TRUCK, UTILITY, LIGHTWEIGHT, FFR, MC2 - LAND ROVER 110 AND TRUCK, UTILITY, LIGHTWEIGHT, FFR, WINCH, MC2 - LAND ROVER 110

RELOCATION OF RAVEN RADIO FRAME MOUNTING

MODIFICATION INSTRUCTION

Figure 1 Schematic of Left-hand Side Installation

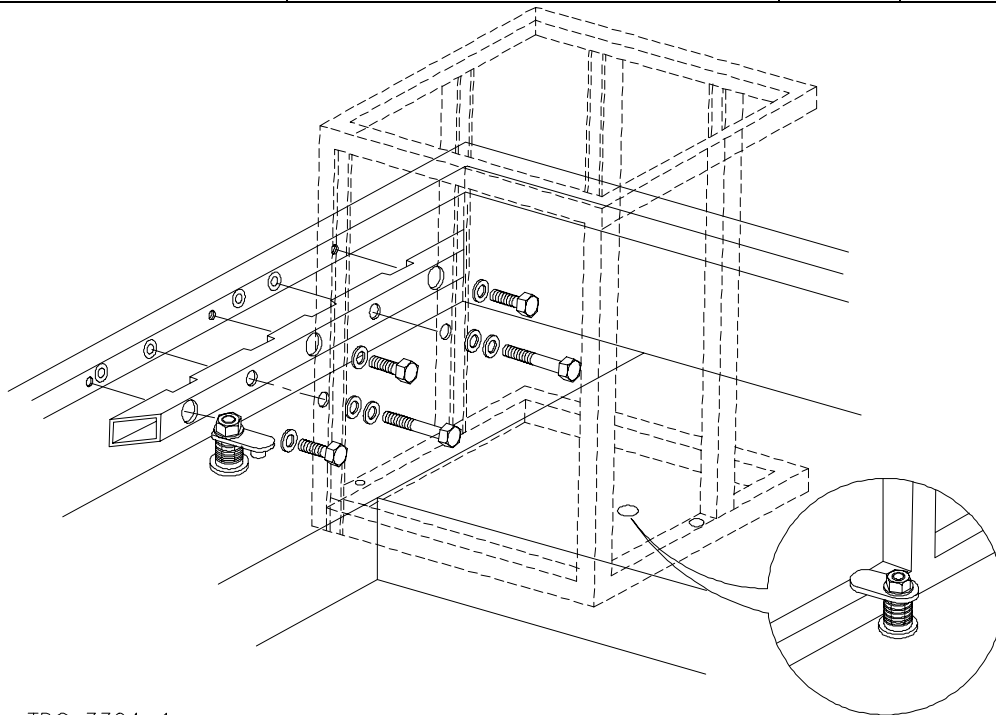
1. This instruction details the relocation of the RAVEN radio frames, inboard by approximately 25 mm. This is due to the fitting of the Roll Over Protection System (ROPS) (see [EMEI Vehicle G 117-1](#)) and is to be actioned at the time of fitting ROPS to vehicles already fitted with RAVEN.

- a. Position the packing tubes (Table 1, Item 2), as shown in Figure 1. Locate the radio frame clamping bolts (Table 1, Item 3), ensuring that the packing tubes are not fouling on other existing rivnuts that are in the capping.

- b. With the packing tubes firmly clamped in position, mark and centre punch the position of the holes (qty 3 each side) for the screws that will secure the packing tubes to the capping.

- e. Using a socket and ratchet handle with applied force, start the first few threads of the self tapping screw. Once all threads are started, remove all screws and then secure the packing tubes, as previously described (shown in Figures 1 and 2).

Figure 2 Packing Tube and Lower Clamp Installation (Right-hand Side Only)

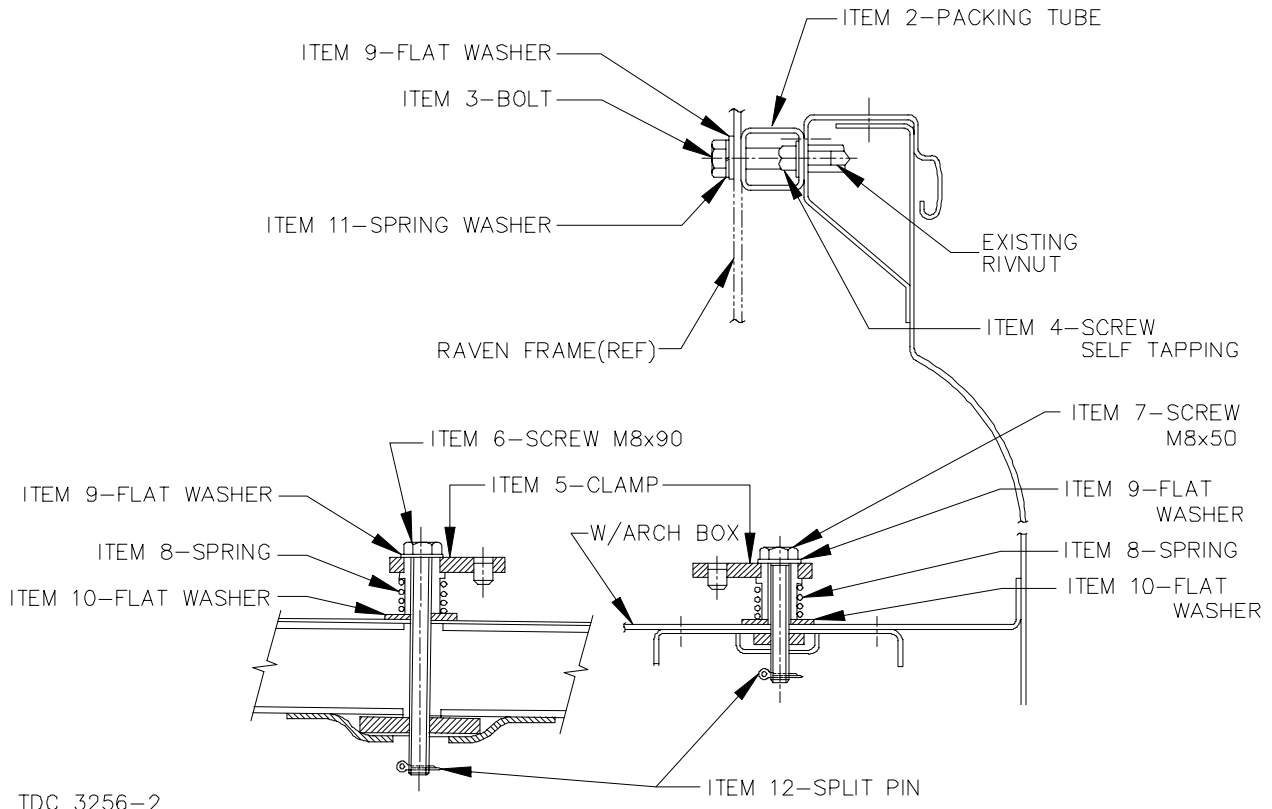
3. This EMEI is essentially a reprint of Issue 1 with minor amendments to the description of items in Table 1 and the labelling of components in Figure 2 to clarify their identification.

- f. Fit the lower frame clamps to the existing threaded plates (fitted below the wheel arch boxes) using the appropriate components (Table 1, Items 5 to 12), as shown in Figure 2. Ensure that the split pin (Table 1, Item 12) is splayed to prevent the loss of the clamp assembly, once fitted.
